SUBJECT: Application for amend to License NPF-51, permitting one-time
 only exception to Surveillance Requirements 4.4.10 to allow
 RCS vent valve RCB-HV-105 to be tested during Mode 3
 operations instead of current Mode 5 or 6. Fee paid.

Subject: Palo Verde Nuclear Generating Station (PVNGS)
Unit 2
Proposed Technical Specification Change -
One Time Exception to Surveillance Requirement
for Valve RCB-HV-105
File: 88-F-056-026; 88-F-005-419.05

This proposed Technical Specification change allows for a one-time only exception to Surveillance Requirement 4.4.10 to allow RCS vent valve RCB-HV-105 to be tested during Mode 3 operations instead of the currently required Modes 5 or 6.

FIGURE 1 : RCS VENTS SCHEMATIC

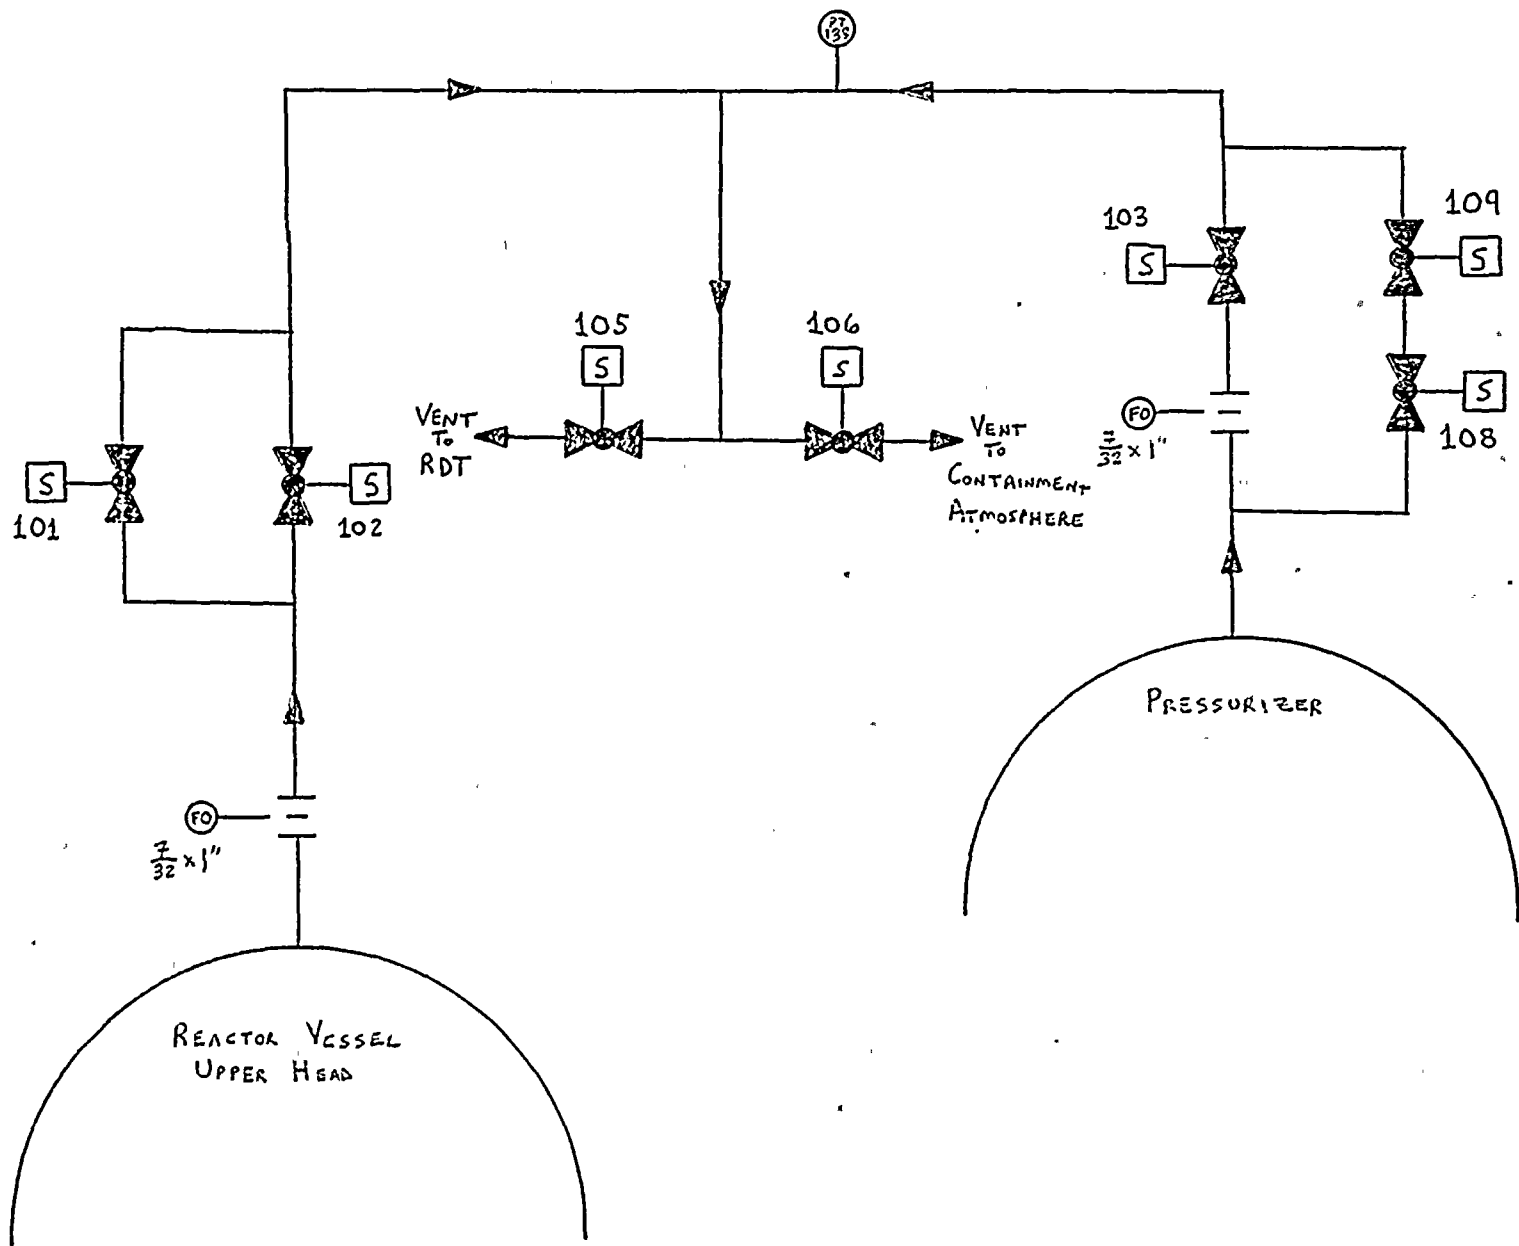
Valve RCB-HV-105 was last tested in November, 1987 during an unplanned reactor shutdown. However, Unit 2 was in Mode 3 during the performance of this test. The test was conducted in a manner such that the safety of the plant would not be compromised during the testing. The test method took advantage of the fact that the line upstream of valve RCB-HV-105 had been partially pressurized due to a slight leak from one of the upstream valves. Valve RCB-HV-105 was then cycled from the control room while verifying that the upstream pressure decreased as the upstream line was vented to the Reactor Drain Tank (RDT). This test method allowed for testing valve RCB-HV-105 without jeopardizing the integrity of the RCS since the upstream valves remained closed during the testing. The proposed change will allow ANPP to credit this previously conducted test on the valve to satisfy Surveillance Requirement 4.4.10.

The RCS vent system is shown in Figure 1. The system provides redundant vent paths from the pressurizer steam space and from the reactor vessel upper head. The vented gases and/or steam can then be directed to either the RDT or the containment atmosphere. The system is composed of seven solenoid operated valves that can be operated remotely from the main control room. The system was installed in the PVNGS units in response to TMI item II.B.1. For further discussion of the system design refer to section 18.II.B.1 of the PVNGS FSAR.
